MIDWEST POOLED FUND PROGRAM

Progress Report - Second Quarter 2010

Midwest Roadside Safety Facility
Nebraska Transportation Center
University of Nebraska-Lincoln

Figure 1. Curved Rail W-beam Transition

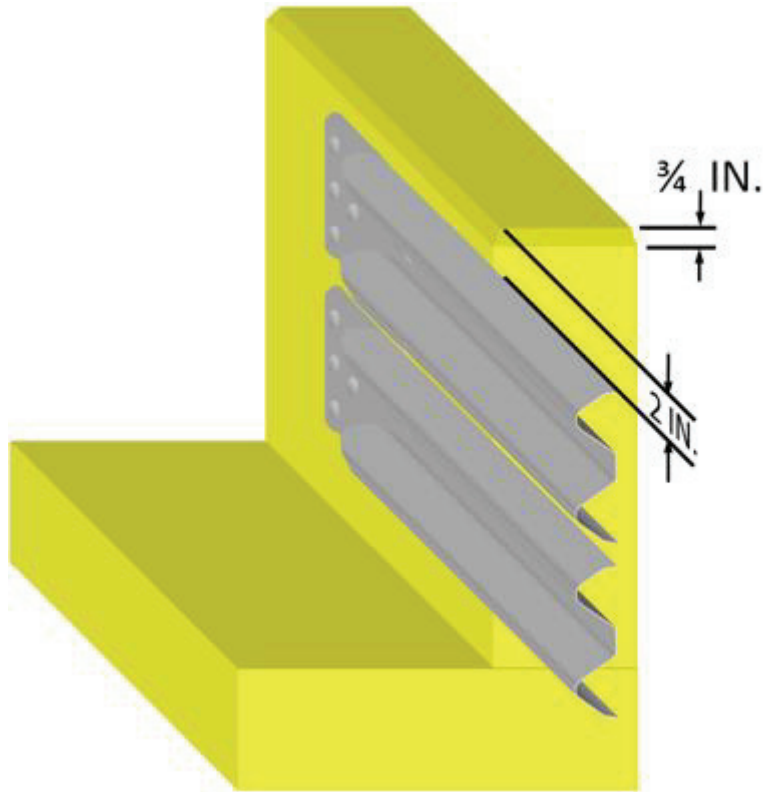
My questions are these. Do you see a snag potential in the as-built condition? If so, is it drastic enough for us to fix it? Grinding the concrete taper is not an option so the only remedy would be to raise the rail: an exercise we don't want to undertake. Of course we will if there is a danger to the public.

Guardrail Clearance Distance

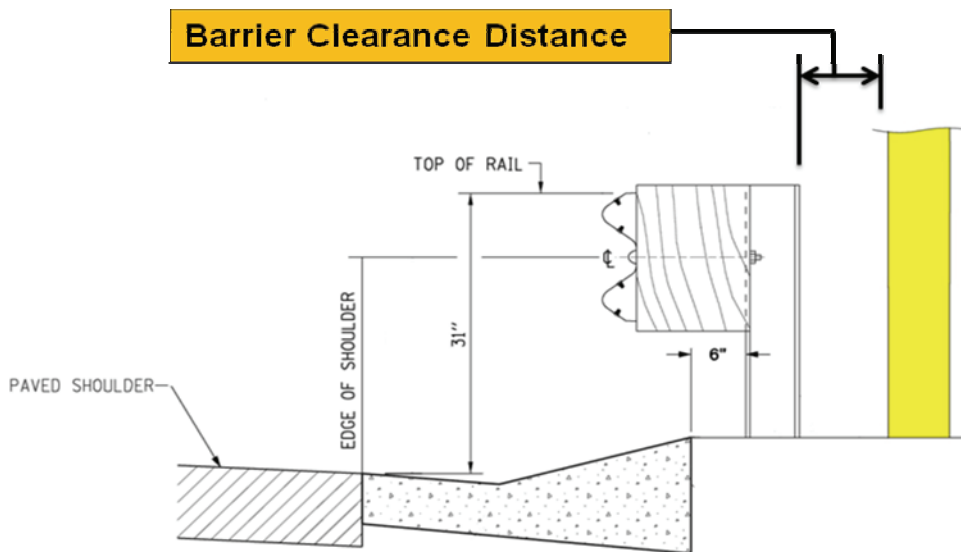
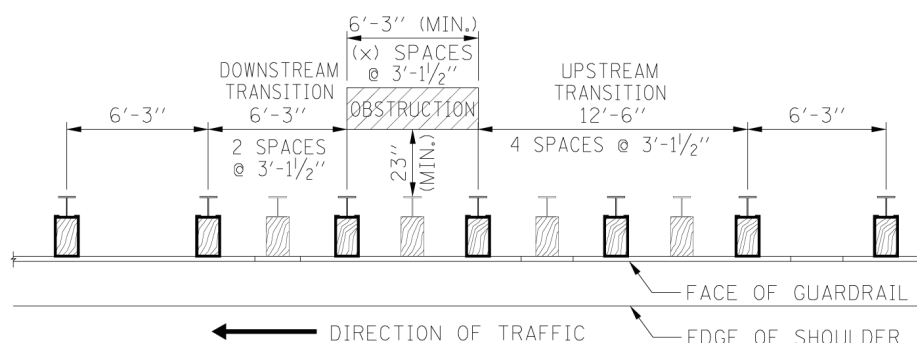
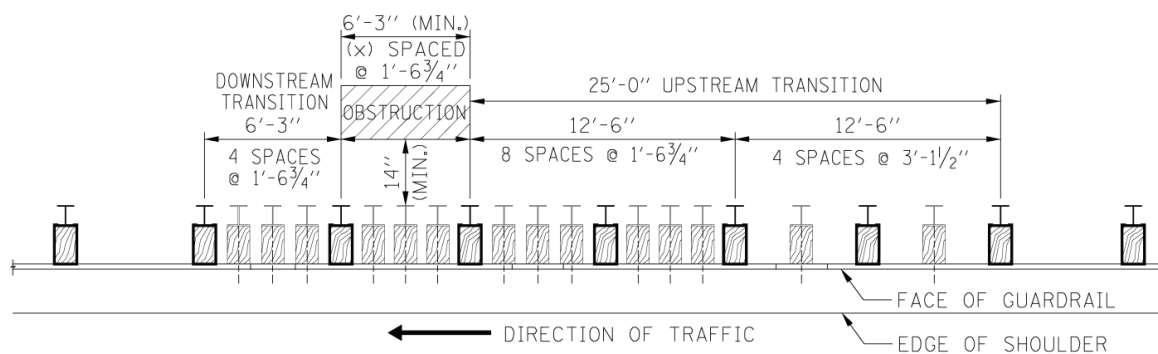
It is not permissible to leave out any posts. Also, additional block-outs are not to be added to provide a greater offset, in order for the post to avoid an obstruction. Block-outs shall not be omitted. For Type A Guardrail, maximum post spacing shall be 9'-6" and minimum post spacing shall be 3'-0"

1. Move conflicting post to the side of the structure that maintains the most even post spacing. Do not exceed maximum post spacing.
2. If maximum post spacing cannot be maintained, then move conflicting post to be adjacent to drainage structure and add one post to be adjacent to the other side of the structure. Posts should be no closer than the minimum spacing. If minimum post spacing cannot be met, then next adjacent post shall be moved to achieve the minimum post spacing. Keep post spacing as uniform as possible to reduce the potential for vehicle pocketing because of the abrupt changes in rigidity. Because the deflection of the rail will be increased in areas where post spacing is increased, the guardrail clearance distance shall be 6' minimum to any nearby hazards.

To answer your question about the use of CRT posts in the Long-span system – They reduce the affects of vehicle snag on the posts. CRT posts are designed to maintain bending strength about the string axis (laterally) but are substantially weaker about the longitudinal direction. Thus, when a vehicle contacts a CRT post, it will fracture or break away and consequences of vehicle snag are minimized.

Second, in circumstances where the hazard/rail is susceptible to impacts from vehicle traveling in the opposing traffic direction, you would want to make the transition symmetric about the hazard (i.e., change the downstream portion to match the upstream.

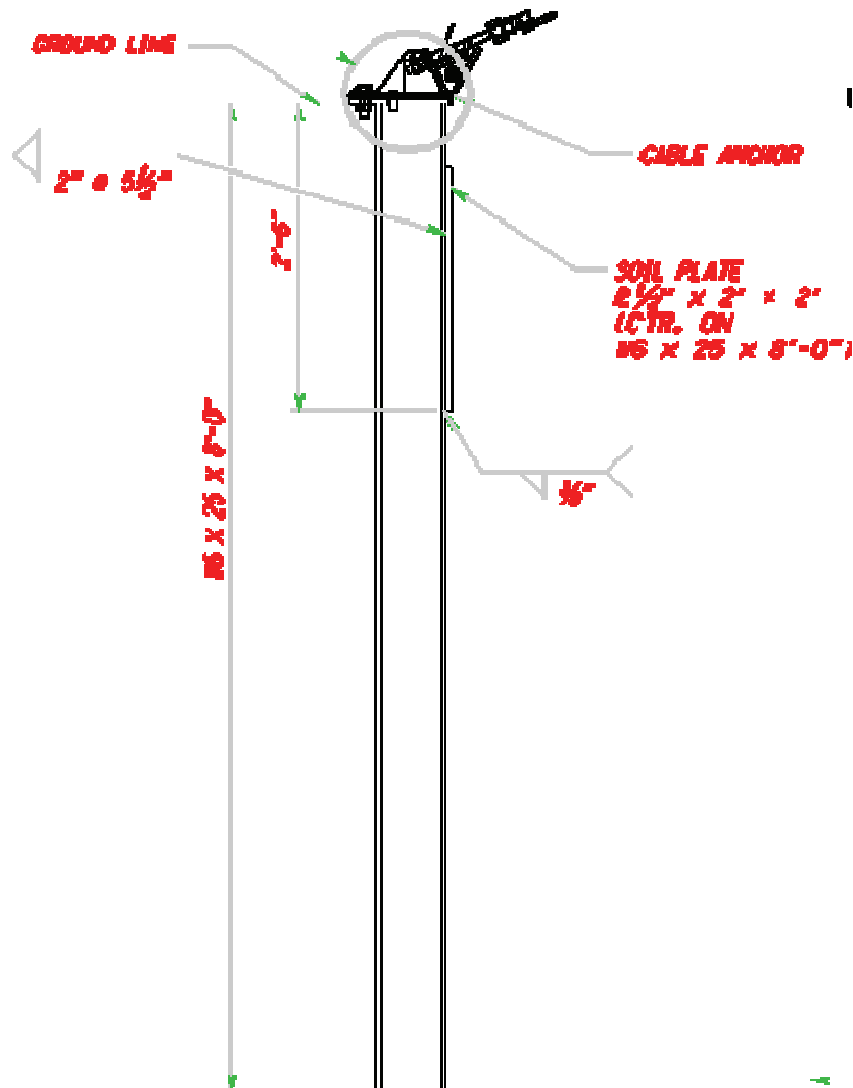
- 1.) Can the soil; plate be bolted to the post after being driven?
The installer would like to drive the post without the soil plate attached.
What size bolts and how many could be used?

2.) Post #2 – the Cable Bracket Detail shows a cut to allow a ¼” x 1.5” piece of metal cut to fold down and hold the cables in place. These break easily sometimes during installation and regularly in a crash.

1) Yes the soil plate can be added after the post is driven into the ground. You will have to dig a hole large enough to properly place the plate on the post – note it is 2 ft wide and extends 2.5 ft below the surface. Also, you will need to compact the soil around the post/plate when the hole is filled. Uncompacted soil will not generate the necessary resistance for the anchor. We use a pneumatic tamper and install soil in 8 inch lifts when we compact soil at our test site.

Figure 5. Cable to W-Beam Transition

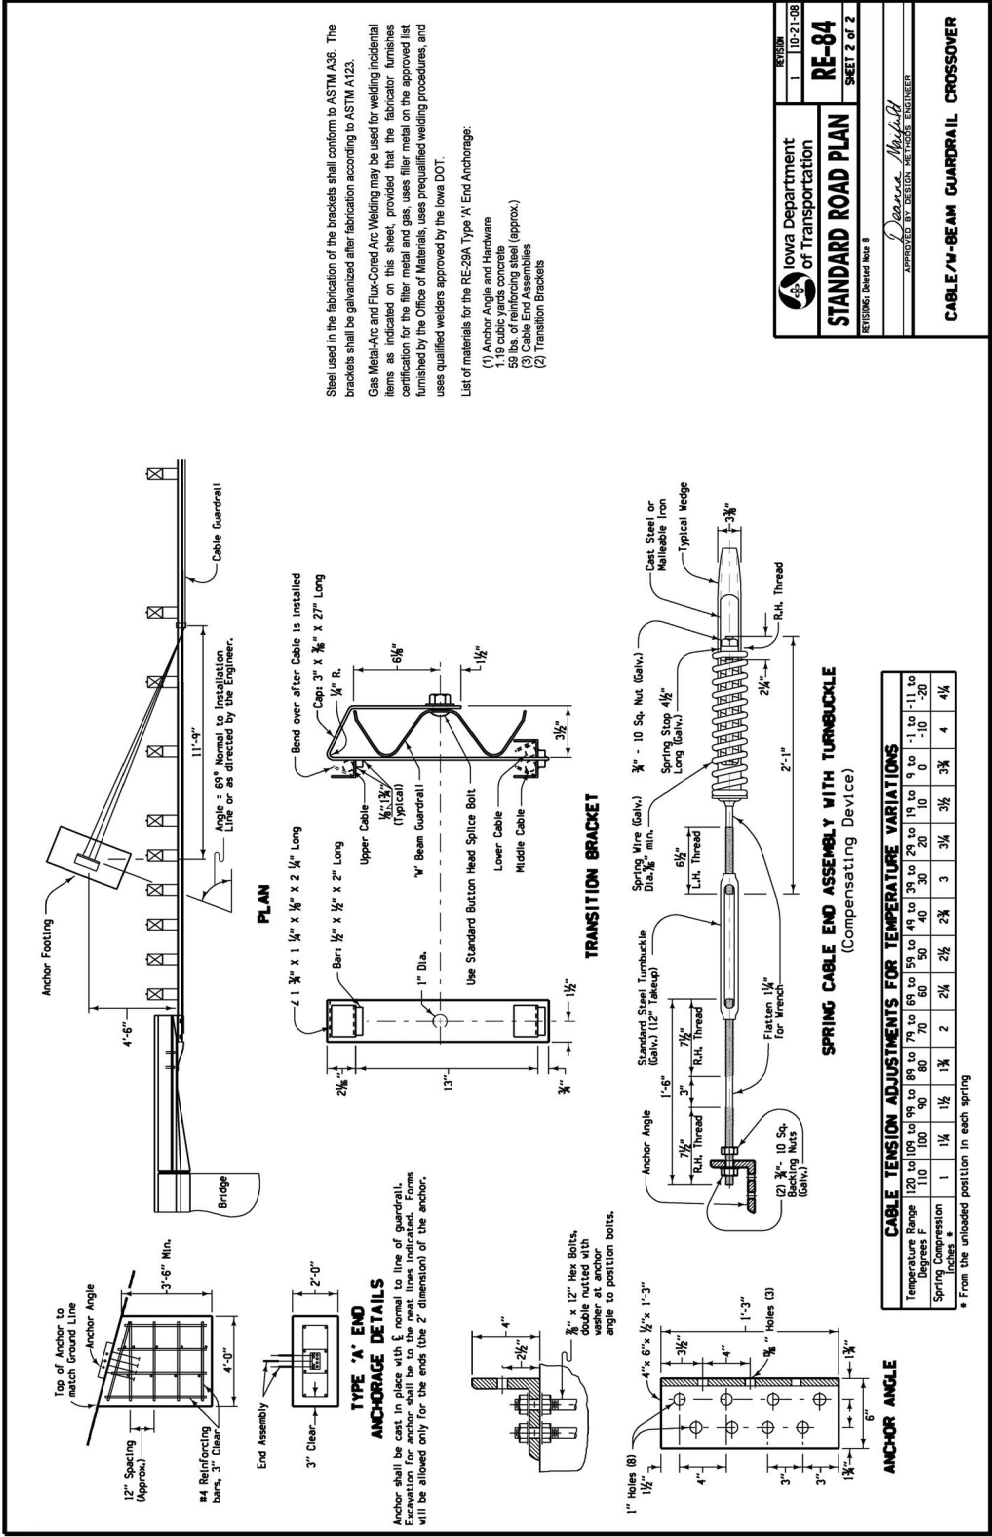
'Case A' on the drawing allows one of the transition brackets to be placed on the w-beam end of the w-to-thrie transition piece. As is clear from the drawing, especially in the plan view on sheet 2, this configuration has proven very difficult to construct; the downstream post and blockout interfere substantially with the path of the cables as they travel from the transition bracket to the end anchor.

In your opinion, should we allow 'kinks' in the cables as they travel around the post and blockout? If not, would we be able to adjust the location of the transition bracket and the end anchor to provide a straight line of travel for the cables?

The second solution proposed by the Iowa DOT was to shift the downstream transition bracket further upstream which would decrease the effective angle to the anchor bracket and allowing the cables to bypass bend locations around the post. While this design would help alleviate cable interference with the post, it is not known what the effect of shortening the overlapped cable length would have on the design. Changing the position of the transition bracket would change the angle of the cables to the ground anchor. One of the concerns in the original design of this system was the potential for snag of the vehicle in the area where the cables angle down towards the ground anchor. Thus, I am leery of changing the transitioning of the cables or the location of the anchorage without further analysis.

An additional option proposed was to drill a hole in the blockout of the post which interfered with the cables. This design option has several advantages, in that the positioning of the bracket and the W-beam do not change relative to each other, minimizing the potential for snagging, pocketing, and loss of cable tension. However, the required size of the hole required to pass the cable through the blockout would be very large, which could lead to lower compressive strength of the blockout, greater propensity for twisting, and the cables would be subject to post rotation or fracture in the soil. Damage to the post at the point of cable routing could interfere with the cable's tension and could potentially cause catastrophic release of the cable from the end terminal. Furthermore, the additional labor required for field drilling holes in the blockout and the potential to cause unexpected damage are high; therefore this is not an optimal solution.

The final design option is to add an additional 12'-6" of guardrail between the the flared crashworthy end terminal and the approach transition. By introducing an additional span of guardrail, transition bracket interference issues, cable tension concerns, and field operations are maintained. In addition, this options allows the cable transition to be completed before the approach transition to the bridge rail begins. Though this may be the be slightly more expensive option, it is nonetheless the most crashworthy from a design standpoint, and will most likely result in acceptable performance of the transition design.

Figure 7. Recommended Cable Anchorage

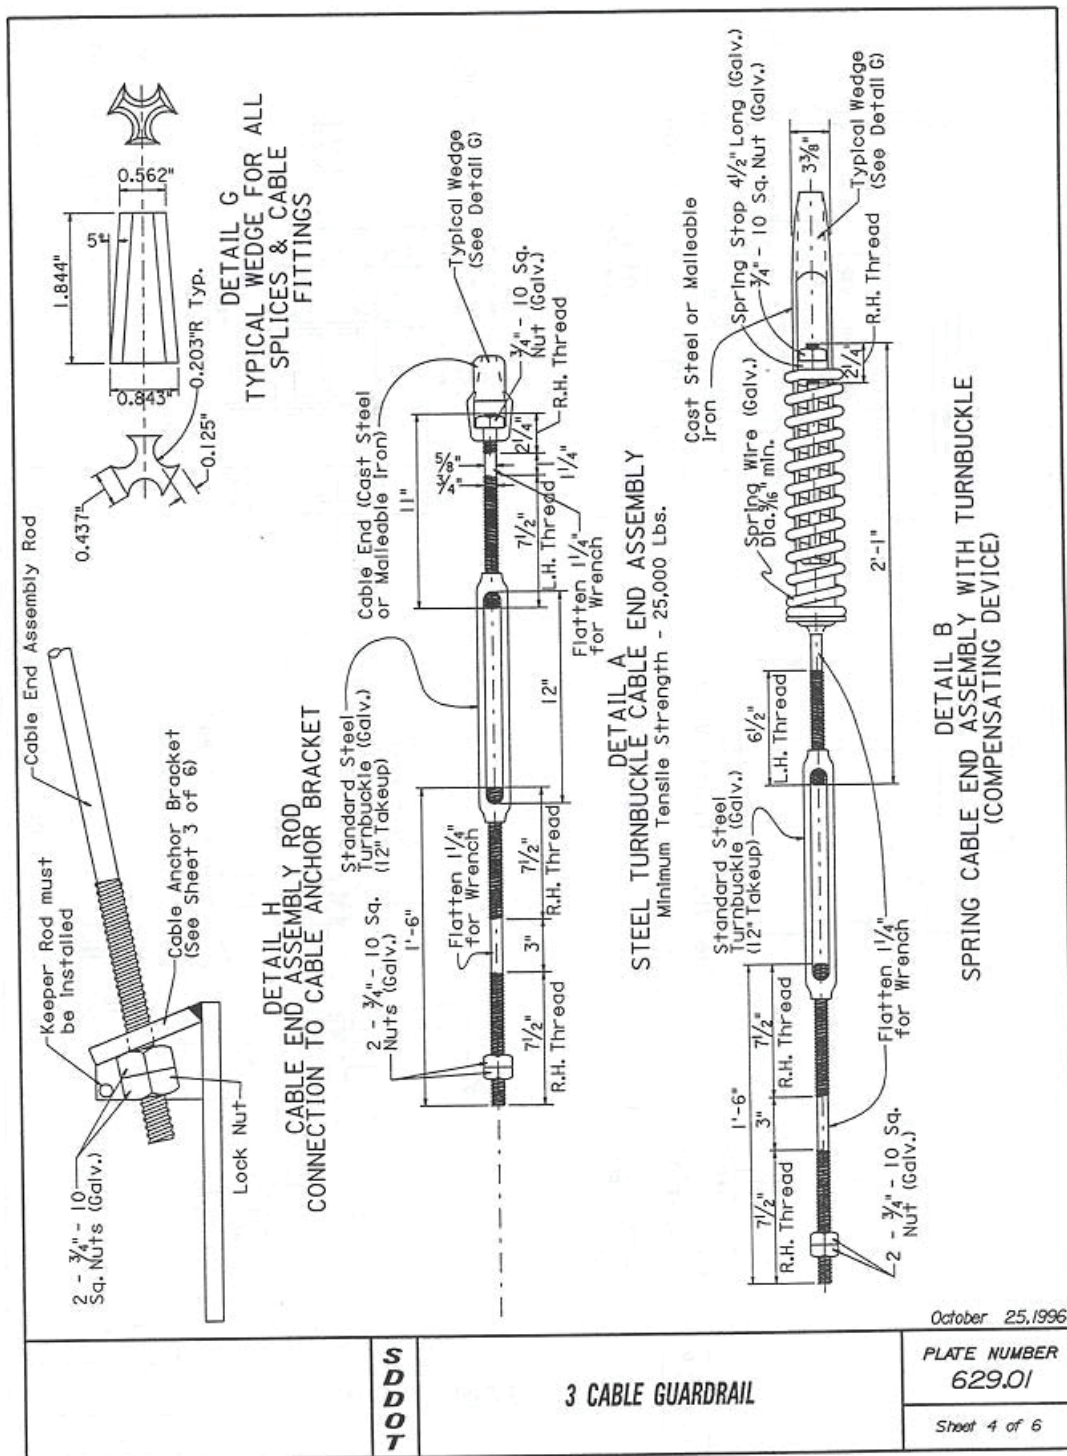
An additional issue which was brought to my attention was the standard plan design of the cable anchor. This cable anchor, a 4" x 4" anchor angle, does not have sufficient strength to maintain the loads from the cables during a crash event. Cable loads on anchors can, in TL-3 crash conditions on low-tension cable guardrail systems, rise as high as 60 kips with peak loads from a single cable as high as 25 kips. It is conceivable that higher-energy impacts may cause tension increases in excess of this number. The angle bracket anchor shown in your detail will most likely not be sufficient to maintain these loads without a large degree of deformation, which may compromise the performance of the anchorage. It is recommended that Iowa adopt the design tested in the test report prepared for the South Dakota Department of Transportation entitled, "Crash Testing of South Dakota's Cable Guardrail to W-beam Transition", by Faller, Sicking, Rohde, Holloway, Keller, and Reid, MwRSF Research Report No. TRP-03-80-98. Anchor bracket design details tested in the report are attached. This design uses a gusseted anchor plate that is significantly stronger.
